# ***Control Room Design Review***

## ***Annunciator Study Report***

**The South Texas Project**

**HOUSTON LIGHTING & POWER COMPANY**

LINE OF SIGHT ORIENTATION  
FOR ANNUNCIATORS  
Figure 3.2-1

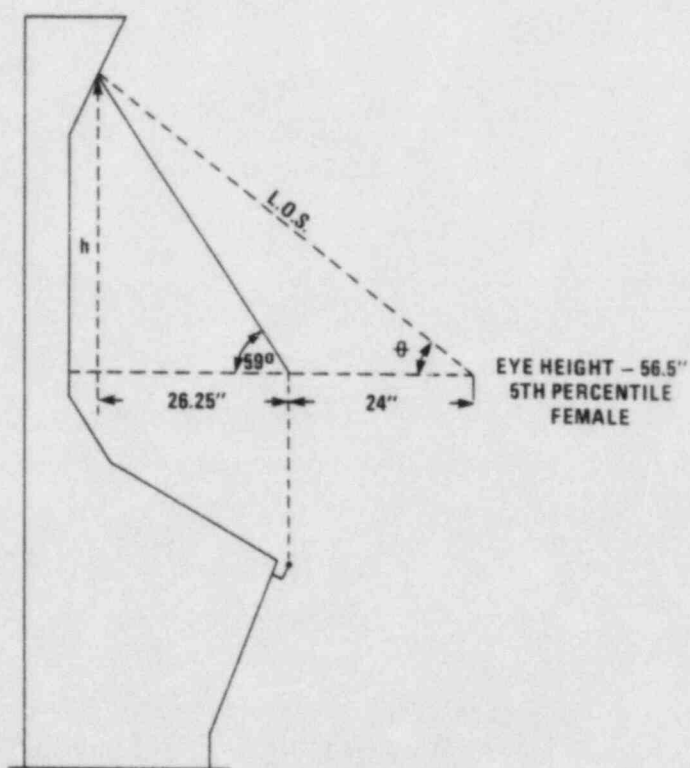
Using data from the Anthropometry Report, the eye-height of the 5th percentile female is 56.5 inches above the floor, and the angle between the horizontal and the line to the center of the alarm section of the board is 59° (see Figure 3.2-1). The horizontal distance between the center of the annunciator windows and the board edge is 26.25. Solving for h, the vertical height

Using this calculated value, and positioning the viewer 24 inches back from the front edge of the board, calculate  $\theta$  and then L.O.S.

$$\theta = \tan^{-1} \frac{43.7}{26.25} = 59.4^\circ$$

$$\text{L.O.S.} = \frac{46.25}{\sin 59.4^\circ} = 54.3''$$
